February 27, 2020

Mr. Scott R. Williamson
Program Manager, Waterways & Wetlands Program
Pennsylvania Department of Environmental Protection
Southcentral Regional Office
909 Elmerton Avenue
Harrisburg, PA 17110-8200

**Re: Hydrogeologic HDD Re-Evaluation Report
Snitz Creek/North Zinns Mill Road Crossing
16" Horizontal Directional Drill Location (S3-0101-16)
Permit No. E38-194
West Cornwall Township, Lebanon County**

HORIZONTAL DIRECTIONAL DRILL
N ZINNS MILL ROAD
PENNSYLVANIA PIPELINE PROJECT

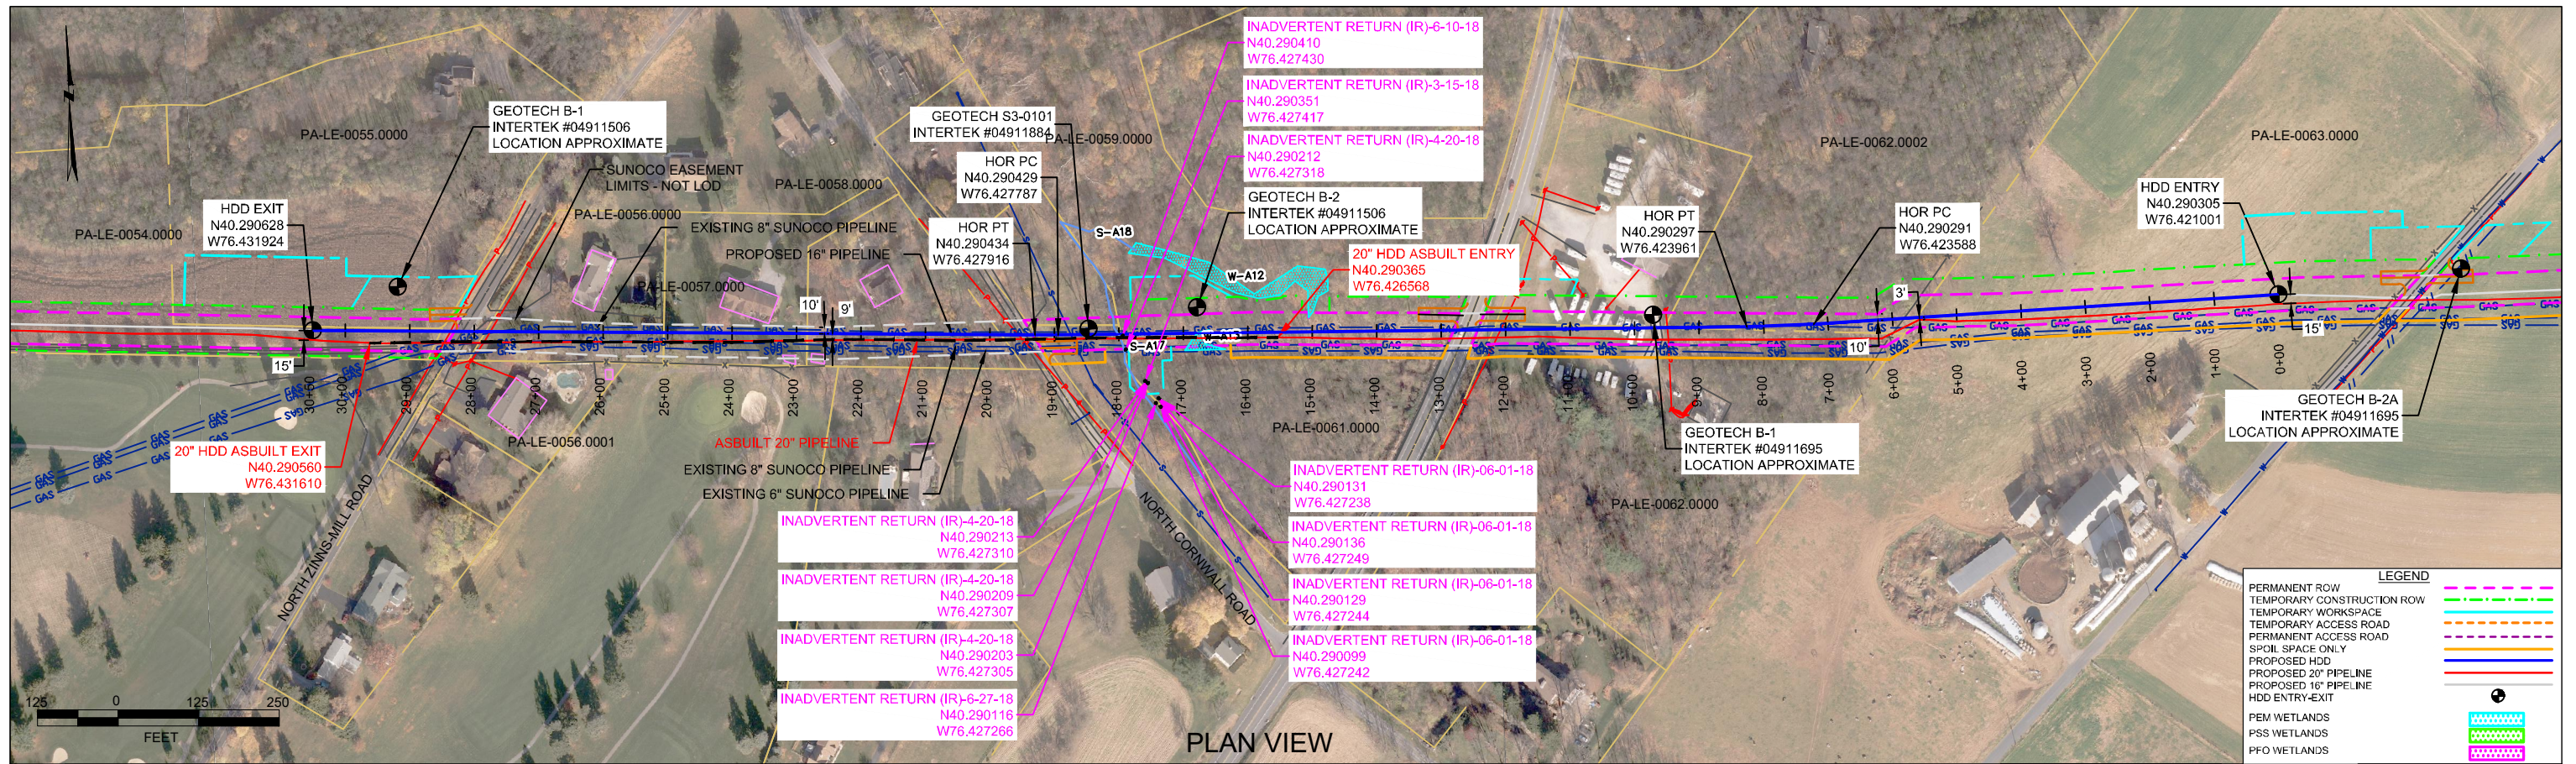
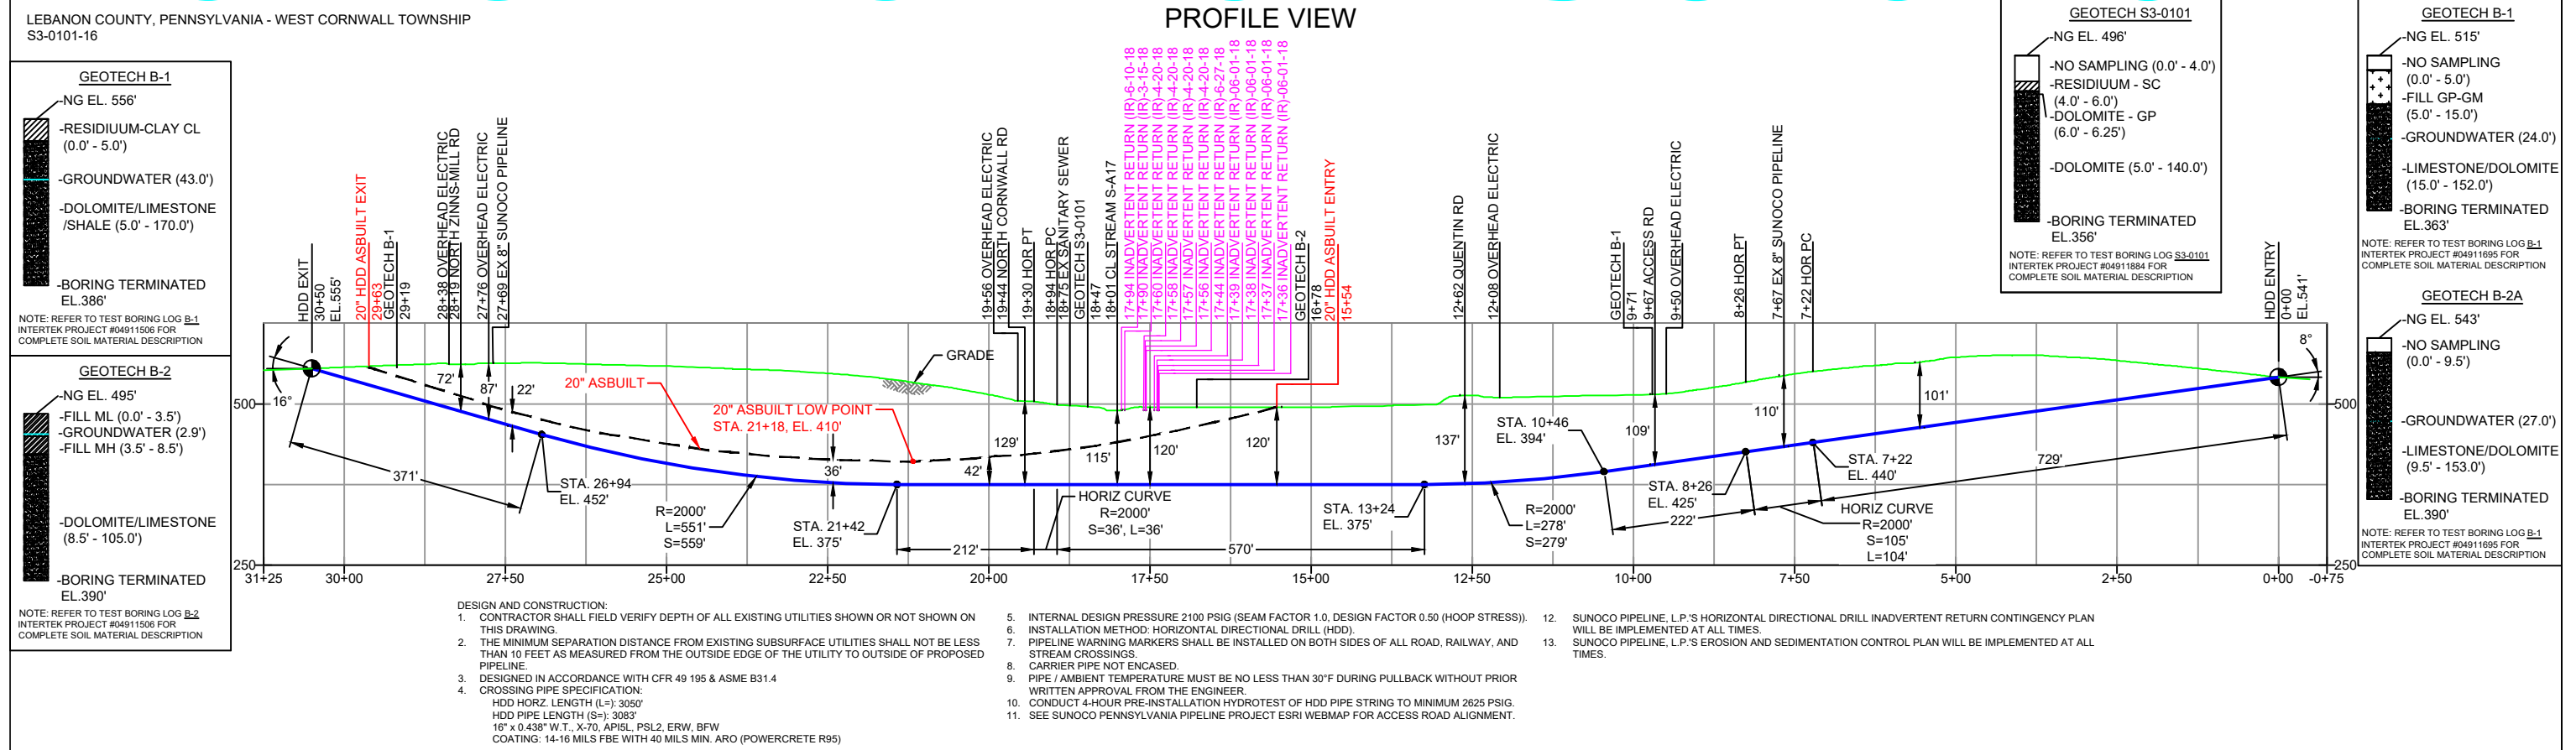
DEP requests that SPLP conduct additional geo-technical investigation of the portion of the HDD profile and area where most of IRs occurred on the 20-inch bore. SPLP should incorporate the results of such additional geo-technical investigation into the HDD re-evaluation. Alternatively, if additional geo-technical investigation is not feasible, SPLP should provide an adequate justification of why collecting such additional data is not feasible. In accordance with Paragraph 5. of the Order, SPLP should collectively use and present all of the available data compiled from the construction of the 20-inch line and any new geo-technical data to explain in detail how the 16-inch profile was chosen in order to minimize IRs during construction of the 16-inch pipeline.

a. Why was the geophysical survey not run across the HDD length and to the proposed HDD profile depth where most IRs occurred in the past? (See comment No. 1, above)

b. Why was the geophysical survey not run across the entire HDD length and to the proposed HDD profile depth? Can any of the geophysical techniques be employed in the area between N. Cornwall Road and Quentin Road or between Quentin Road and the revised entry to the east?

c. If additional geophysical data can be obtained, please submit additional plan/profile maps with superimposed geophysical data.

As referenced in the August 29, 2019 response letter, SPLP utilized all the information obtained during completion of the 20-inch HDD, as well as the 2017 geotechnical investigation and the 2018 and 2019 geophysical surveys, in our internal assessment and evaluation of the 16-inch HDD profile. This information, which included annular pressure measurements, rates of advancement, cuttings (lithologic) observations, and the force (weight on bit) applied during drilling operations, as well as geologic information ascertained from the 2017 geotechnical investigation and the 2018 and 2019 geophysical surveys, was utilized to determine that the originally permitted 16-inch profile was susceptible to IRs. The information was also taken into account when redesigning the 16-inch profile to achieve a greater depth and quicker entry/exit into competent bedrock.

Based on this uncertainty relative to the dip of the beds within the proposed 16-inch profile, SPLP elected to install an additional geotechnical boring to the east of Snitz Creek, as illustrated in the enclosed geotechnical investigation report. The location for the boring was selected to provide geotechnical data along the profile in the area where the IR source area is suspected to be located. The boring was completed in January 2020 and was completed to a total depth 20 feet below the bottom of the proposed HDD profile. A review of the boring log shows that the subsurface immediately at the HDD profile’s passage under Snitz Creek is comprised of weathered dolomite with fractures and highly broken zones from 6 to 90 feet of below ground surface (bgs), with resulting variations throughout in Rock Quality Designation (RQD) and recovery values. From 90 feet bgs to 115 bgs, RQD values ranged from 68 to 99, and recoveries were 100. The RQD values for the 5-foot sample interval above and below the proposed profile depth were 68 and 61, respectively. These RQD values are indicative of competent bedrock overlying the HDD profile for the horizontal run for 412 feet before and 341 feet after the geographic location of the IR events during the 20-inch HDD. Additionally, the eastern radius and entry/exit run maintains a depth of profile below 100 ft below ground surface until 500 ft before the east entry/exit point. On the 20-inch HDD no issues occurred as the HDD progressed west of Snitz Creek. The results of this boring illustrate that the revised profile has been designed to advance through more competent bedrock than the original 20-inch profile. Based on the revised profile, the potential for IRs has been reduced.

Based on the saturated and overgrown conditions encountered in and around Snitz Creek, it was not and is not possible to complete a geophysical survey that will produce accurate, meaningful, and defensible data. It was because of this inability to obtain defensible data with regard to true bedrock conditions that SPLP elected to install an additional geotechnical boring in the suspected source area for the 20-inch HDD IRs.

No additional geophysical data can be obtained from the areas that were previously not surveyed. Since additional geophysical surveys cannot be completed, SPLP elected to install an additional geotechnical soil boring to evaluate bedrock conditions in the suspected source area for the 20-inch HDD IRs. The results of the geotechnical investigation are attached.
